Date: **August 29, 1994**

Subject: **ELECTROLYTIC CAPACITOR  
REPLACEMENT—GA BOARD**

Model: **BVM-1310/1311/1315/1316/1316C  
BVM-1910/1911/1912/1915/1916/2811**

**Figure 1**

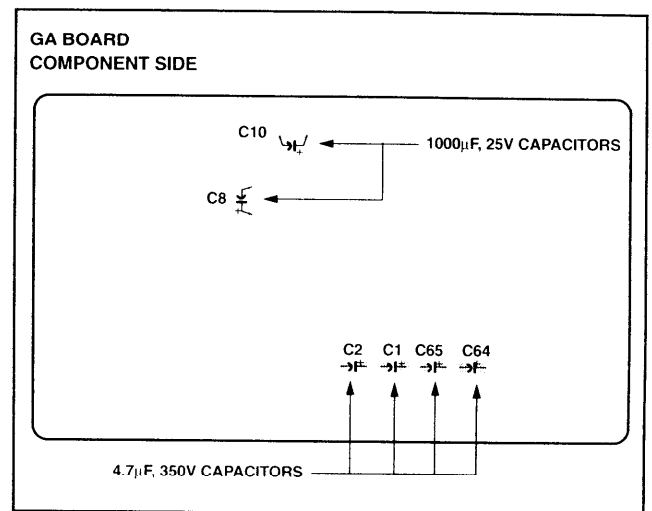
To improve reliability of the power block, replacement of the following electrolytic capacitors on the GA board may be necessary. (See Figure 1.)

- C1, C2, C64, C65 (1-124-024-00, 4.7 $\mu$ F, 350V)
- C8, C10 (1-124-525-11, 1000 $\mu$ F, 25V)

Figure 2

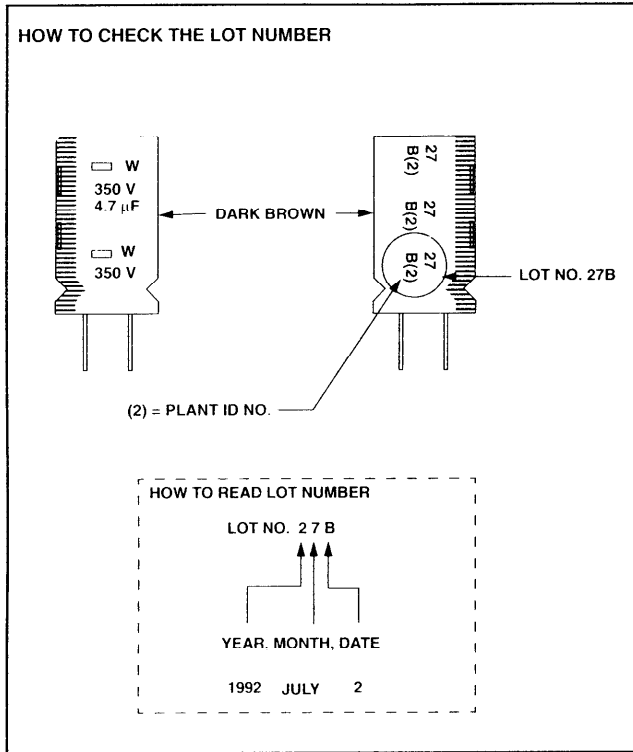
1. Check lot numbers of C1, C2, C64 and C65. (See Figure 2.)
2. If capacitor with lot number "27B" is mounted, replace it with a new one.

Figure 3

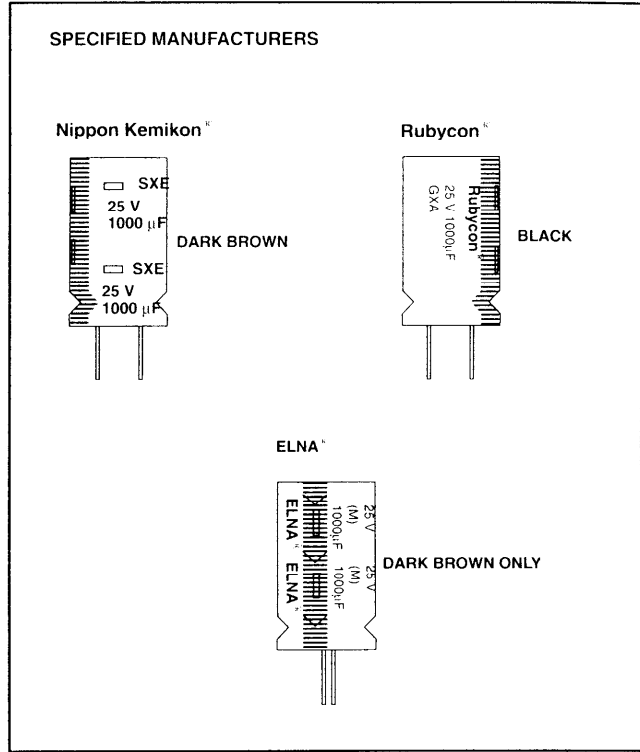
3. Check the manufacturer of C8 and C10.
4. If C8 or C10 is not manufactured by Nippon Kemikon<sup>®</sup>, Rubycon<sup>®</sup> or ELNA<sup>®</sup>, replace it with a new one.

Figure 3 shows where the lot number is located on the capacitor.
